**ONE - GIRDER - 211G3C**  
 FOR FIELD SPLICE STANDARD DETAILS SEE DRAWINGS X202 & X206.  
 FOR GIRDER STANDARD DETAILS SEE DRAWING X205.  
 FOR CAMBER & FLANGE DIAGRAMS SEE DRAWING C203.  
 FOR GENERAL NOTES SEE DRAWING GNI.  
 T2 DENOTES MATERIAL SUBJECT TO CHARPY V-NOTCH TESTING.

**CASCO BAY STEEL STRUCTURES, INC.**  
 1 WALLACE AVE. PHONE (207) 780-6722  
 SOUTH PORTLAND, ME 04106 FAX. (207) 780-6726

STRUCTURE: I-91 BRIDGE 6S OVER WHITESTONE BROOK & WILLIAMS STREET COUNTY OF MINDHAM  
 DRAWN: JTB DATE: 07/11  
 CHECKED: TJB DATE: 07/23

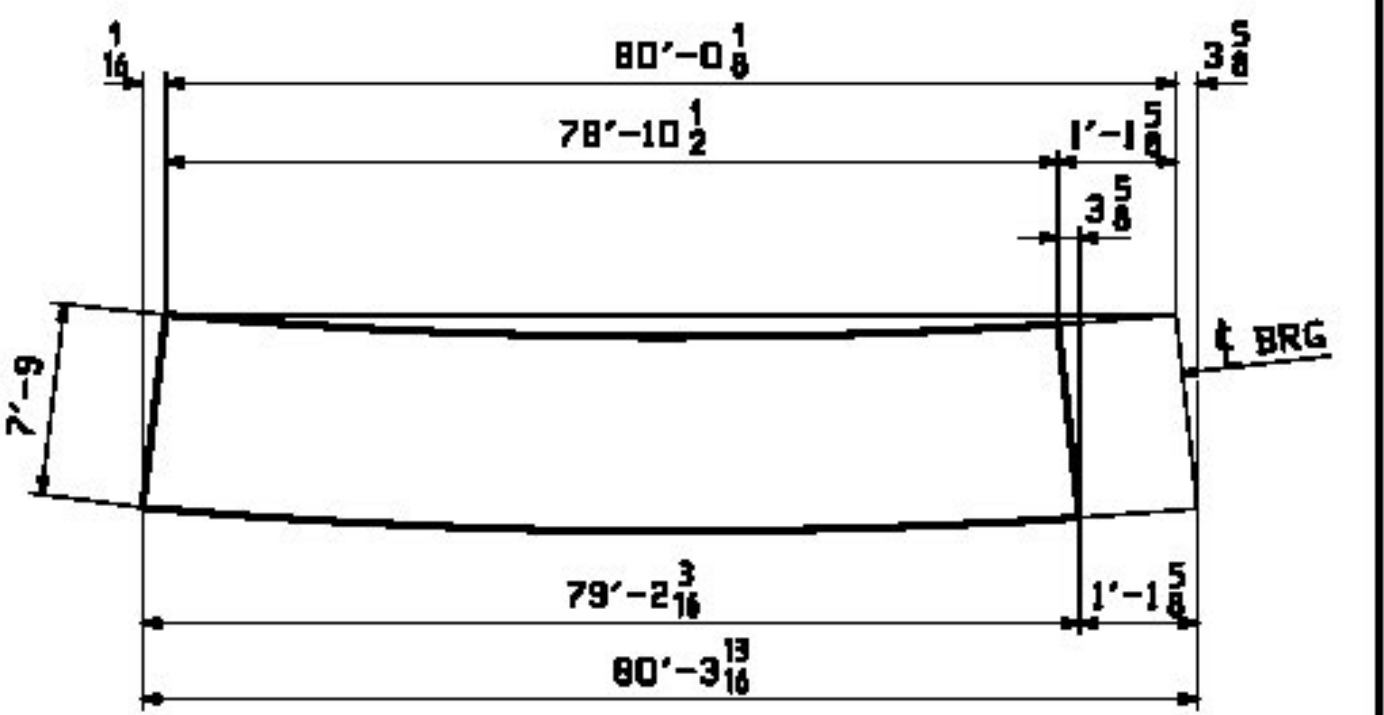
REV.	DATE	REMARKS	DMN	CHK	APVL	SHOP
5/10		REV. UTILITY STIFF'S SECTION B)	JTB	TJB		
5/12		(EXTRA TPC-303400)	JTB	TJB		
7/29		APPROVE CORRECT: ADD NOTE "W" AND 1/2" WEB TO FLG WELD	JTB	TJB		
0

NOTE "W"  
 SEE DETAIL "G4C" ON DRAWING C203 FOR  
 WEB TO FLANGE WELD SIZE TRANSITION LOCATIONS.
